SUBJECT: Contract 9160  
SR99, AWV-Replacement South Access SR99 Connections  
**CHANGE ORDER #022**  
**SR99 Roadway Settlement Repair**

CONTRACT NO: 009160 FEDERAL AID NO:  
CONTRACT TITLE: SR 99, ALASKAN WAY VIADUCT - REPLACEMENT SOUTH ACC  
CHANGE ORDER NO: 22 SR99 ROADWAY SETTLEMENT REPAIR

**DESCRIPTION OF WORK**

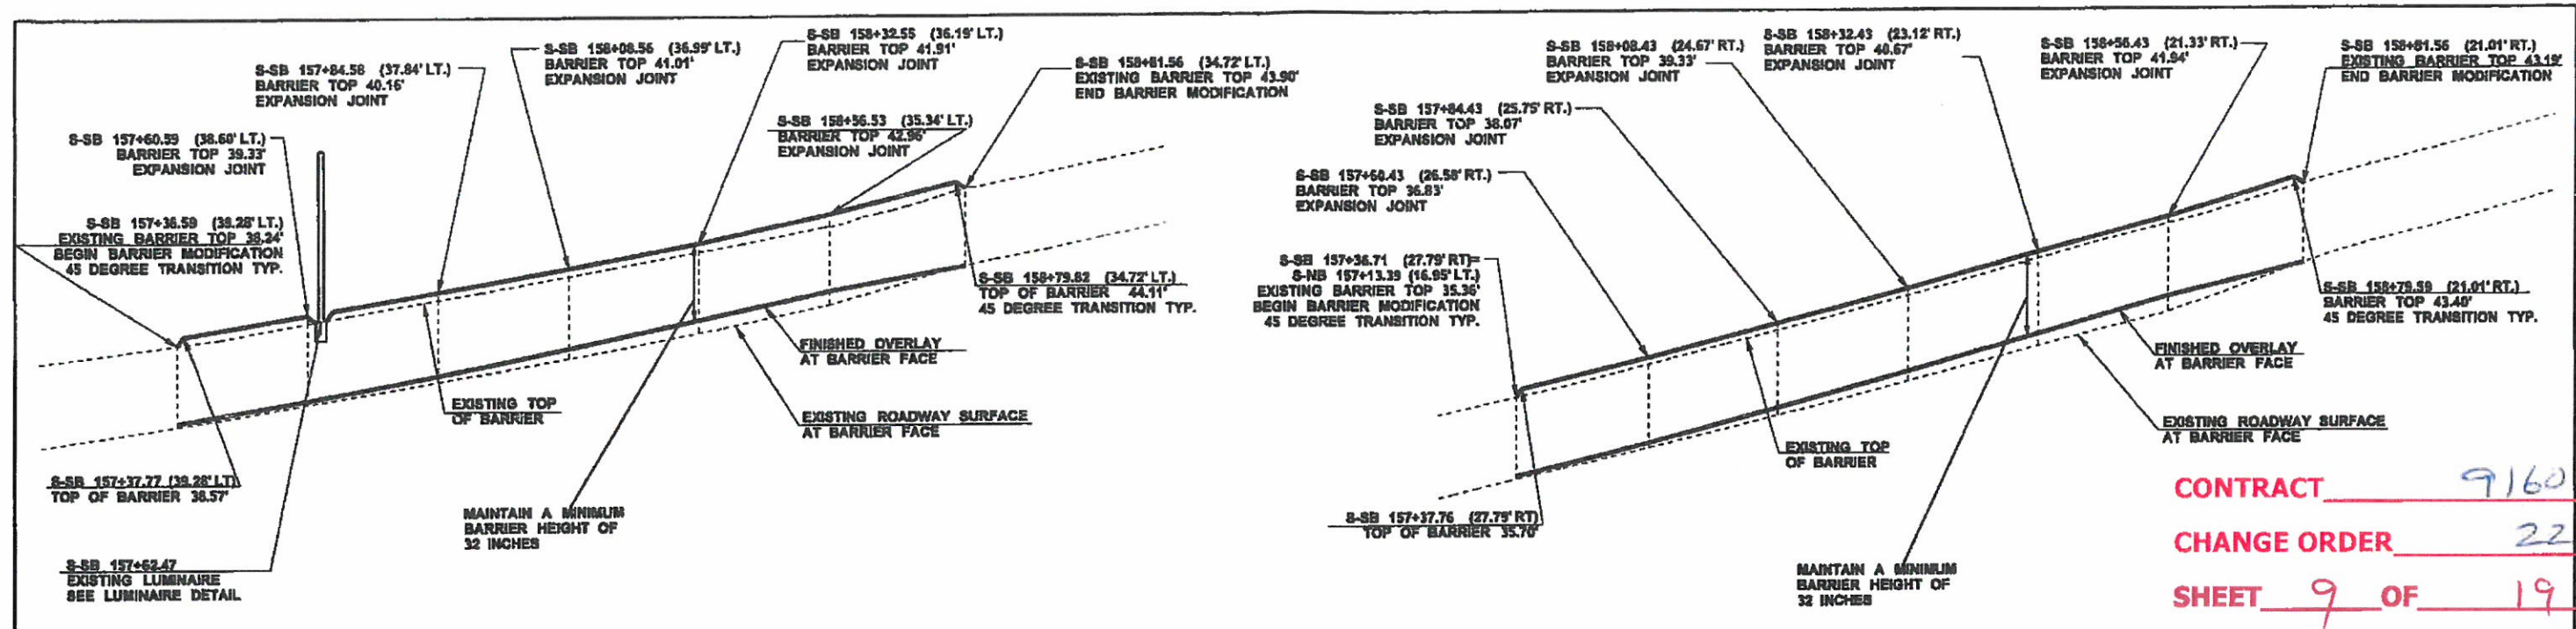
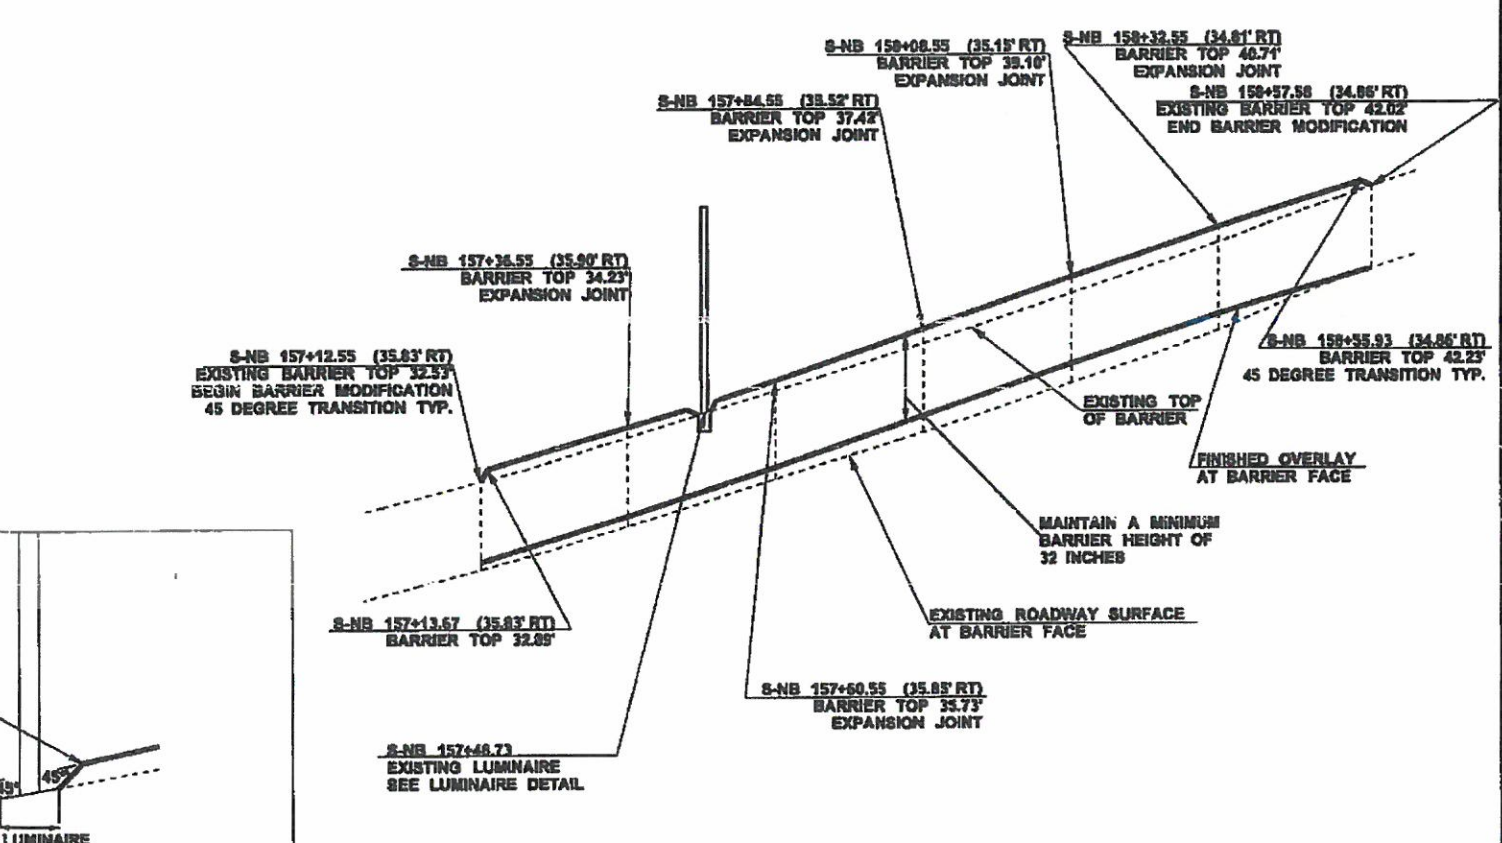
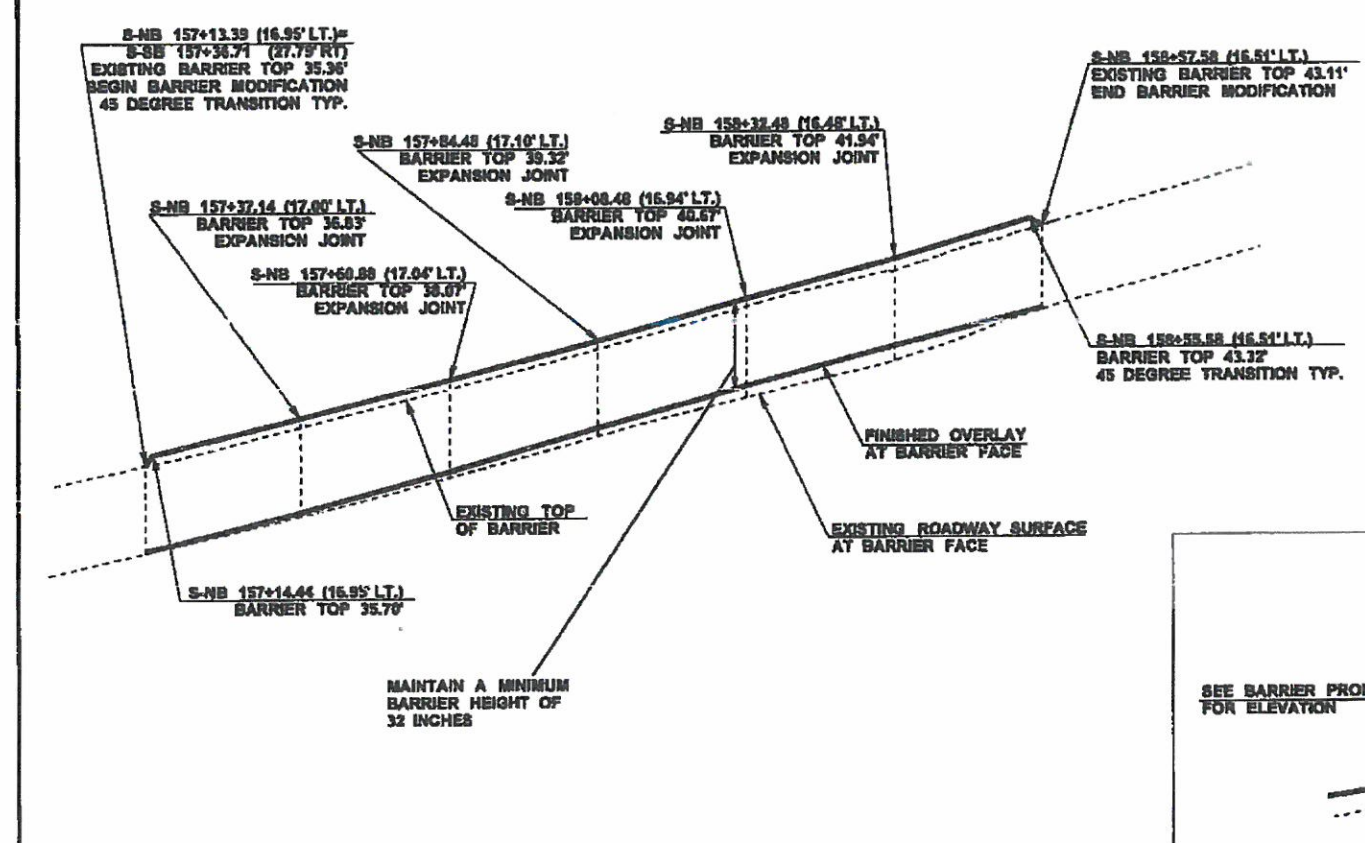
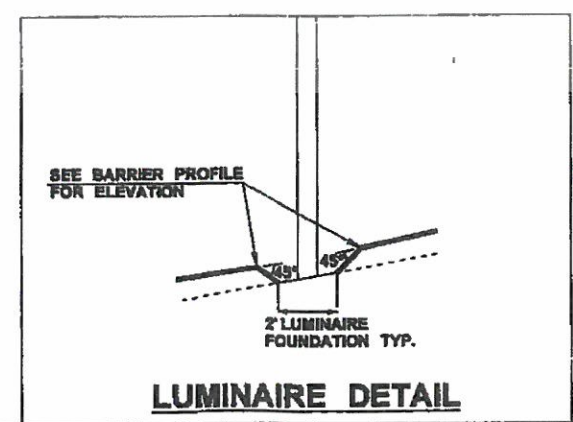
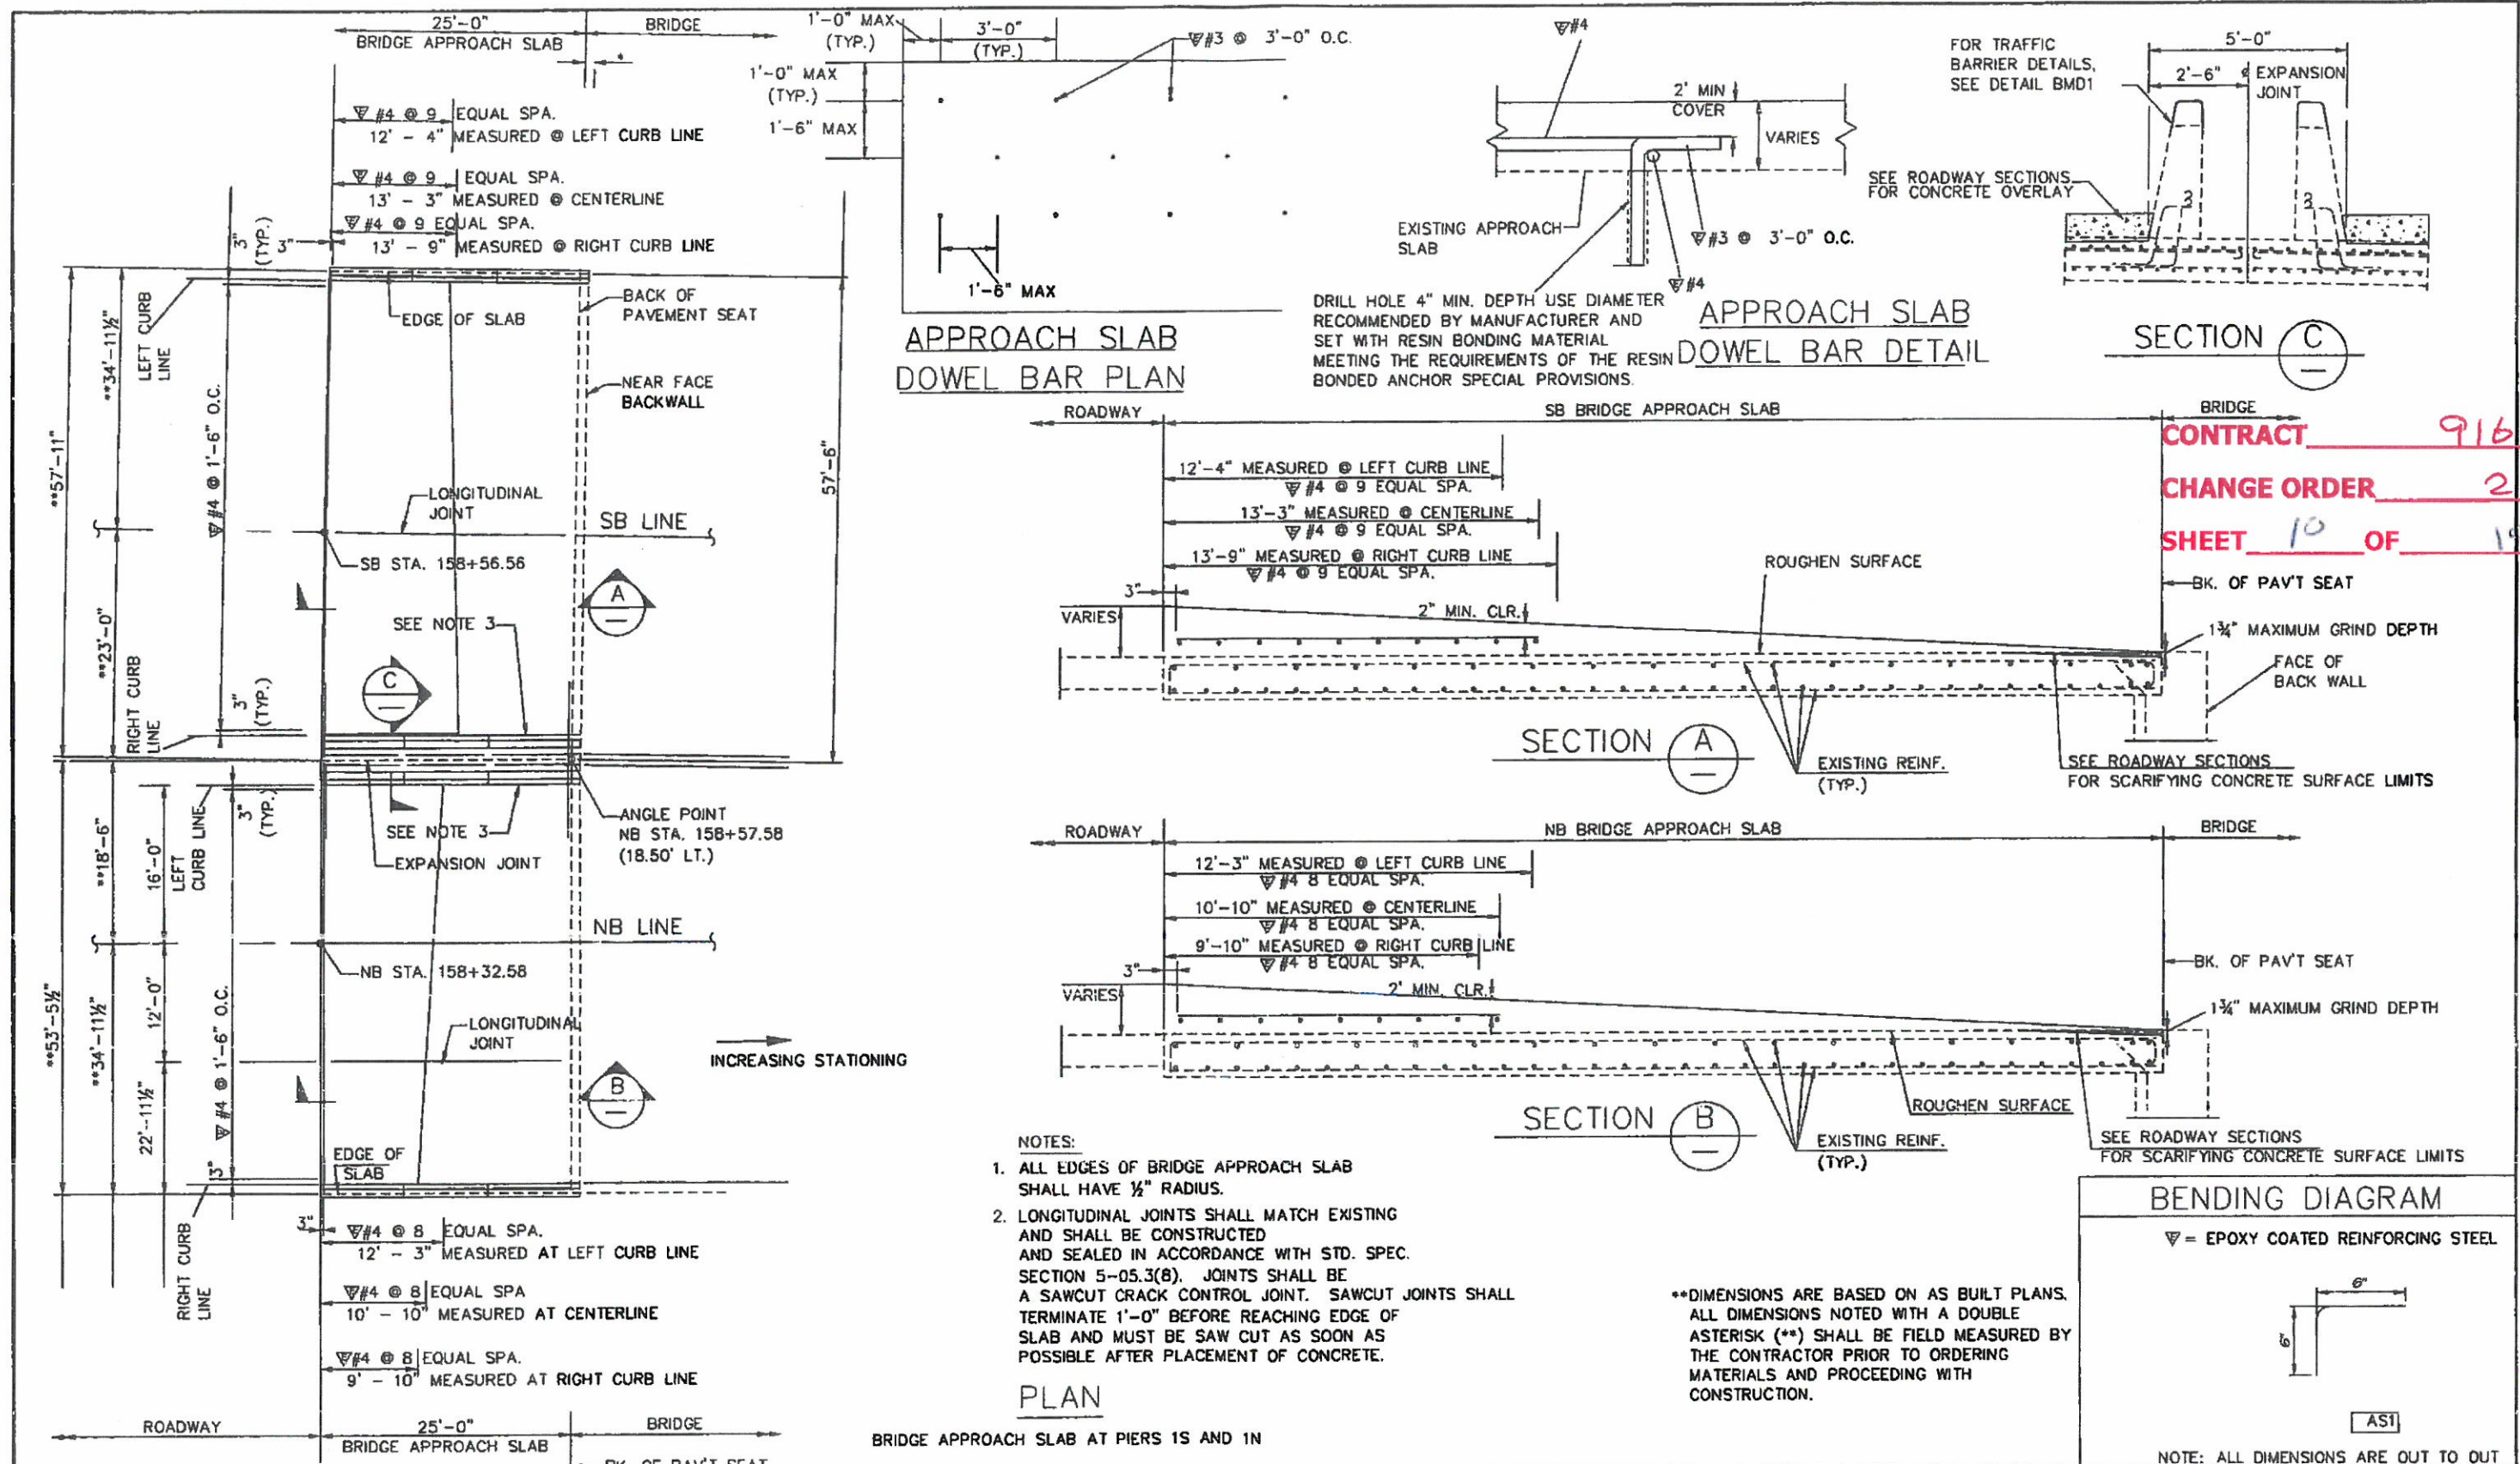
- (5) Modifies the barrier at the following locations:
  - S-SB 157+36.59 (39.36' LT) to S-SB 158+81.56 (34.72' LT)
  - S-SB 157+36.43 (27.29' RT) to S-SB 158+81.56 (21.01' RT)

- S-NB 157+13.39 (16.95' LT) to S-NB 158+57.58 (16.51' LT)
  - S-NB 157+12.55 (35.83' RT) to S-NB 158+57.58 (34.86' RT)
- (6) Implements the traffic control as shown in the plans. Adds temporary barrier and temporary striping to shift traffic in order to maintain access.
